## MATERIALS LICENSE

Amendment No. 05

1. Gelman Sciences
2. 600 South Wagner Road  
Ann Arbor, MI 48103-9019

3. License Number 21-26088-01 is renewed in its entirety to read as follows:

Figure 1

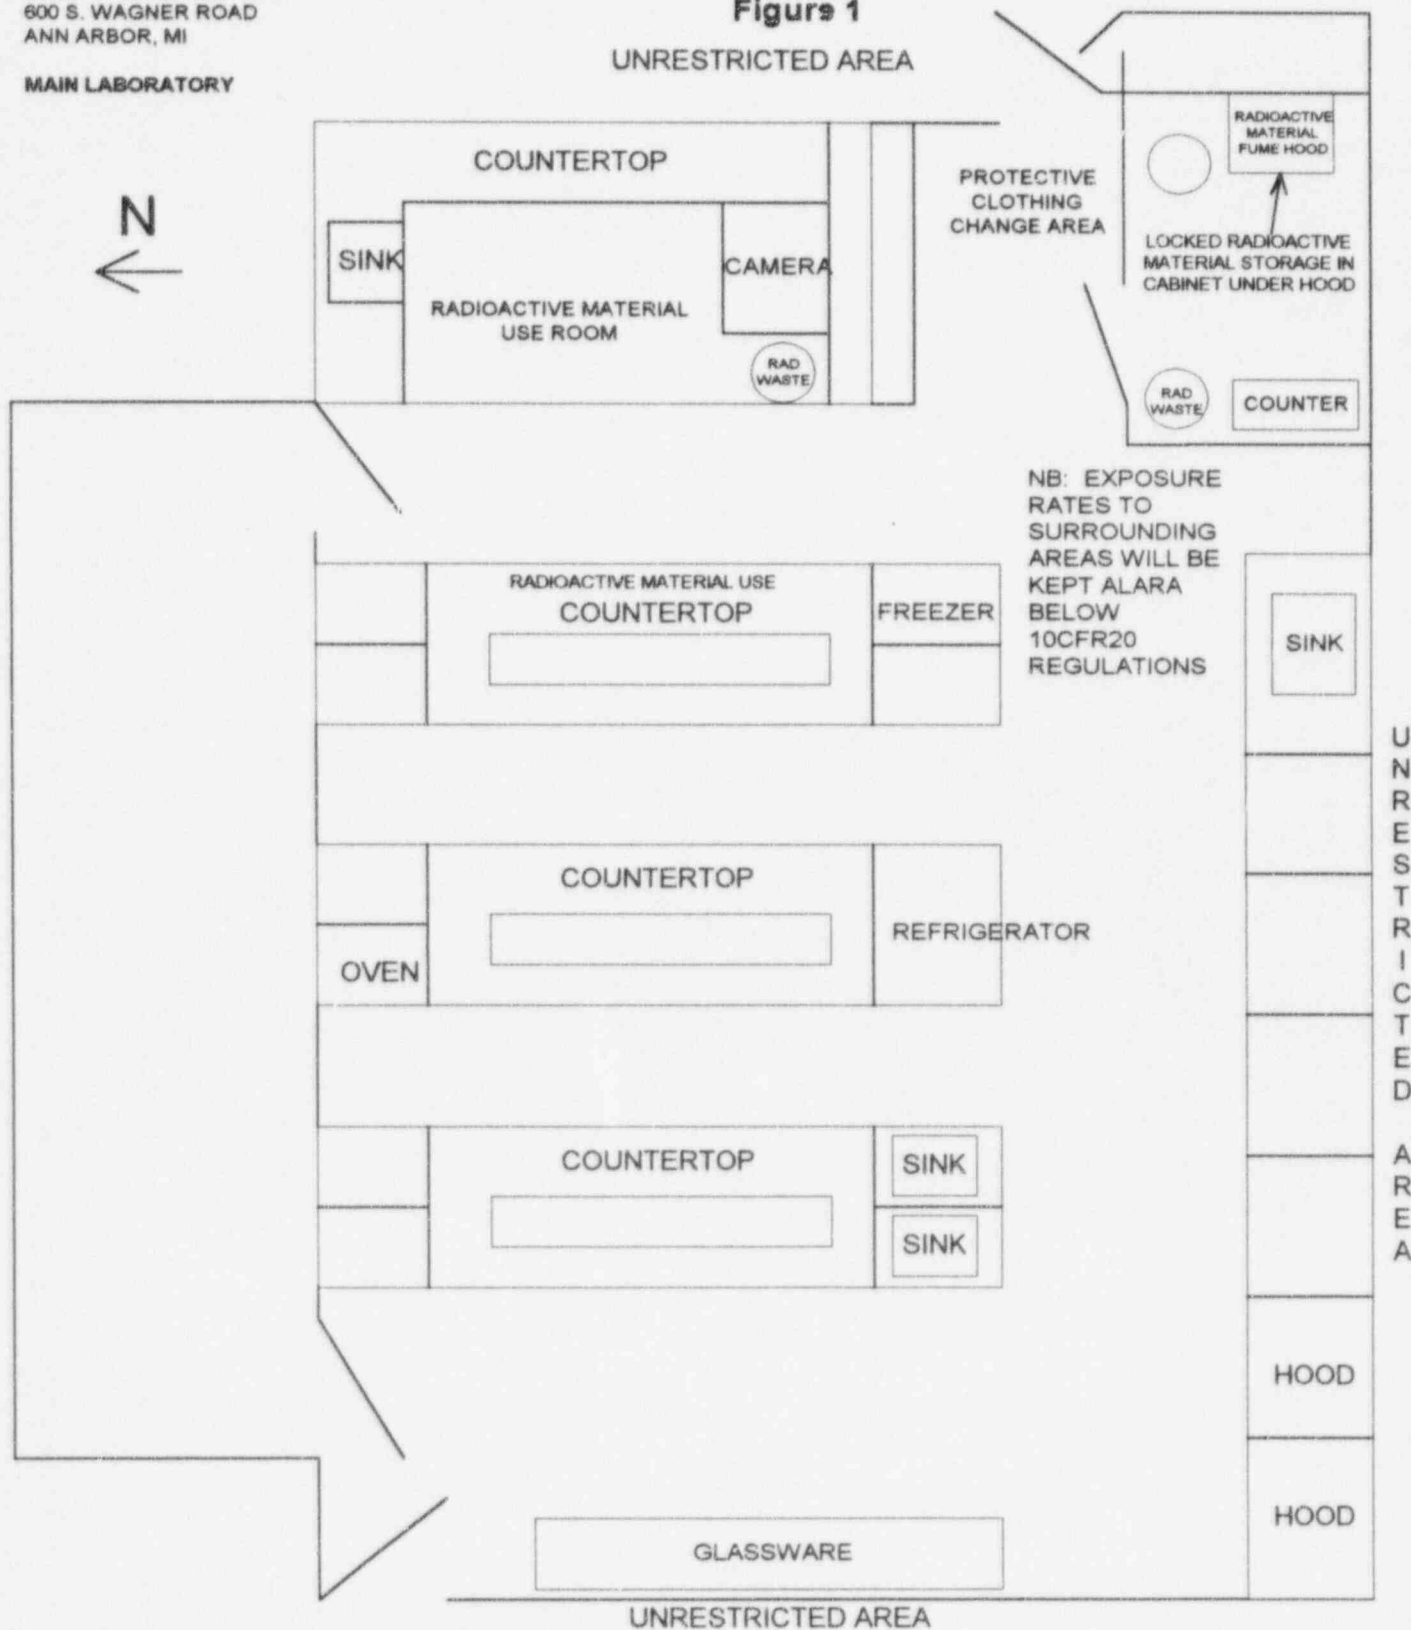
- ✓ 6. Provide a complete description of the location and facilities used to store radioactive waste. Is the area in a separate building? Describe security, weather protection, fire detection and suppression, and other uses of the area.

**Response to Item 6:** A map of the waste storage facility has been inserted in Item 9 of the NRC Application. The radioactive waste storage facility is a detached, heated structure with doors that are locked on the off-hours (5:00 P.M. to 7:00 A.M.). The dimensions are 124' by 40'. The building has a fire detection system as well as a fire suppression system. Other uses of the structure are for the storage of liquid hazardous waste, virgin chemicals, as well as excess stock from the warehousing operation. The radioactive materials storage area is a separate fenced in area that is marked and labeled with a "Caution Radioactive Material" and yellow/magenta tape. Section 3.13.4 describes how the waste area will be monitored.
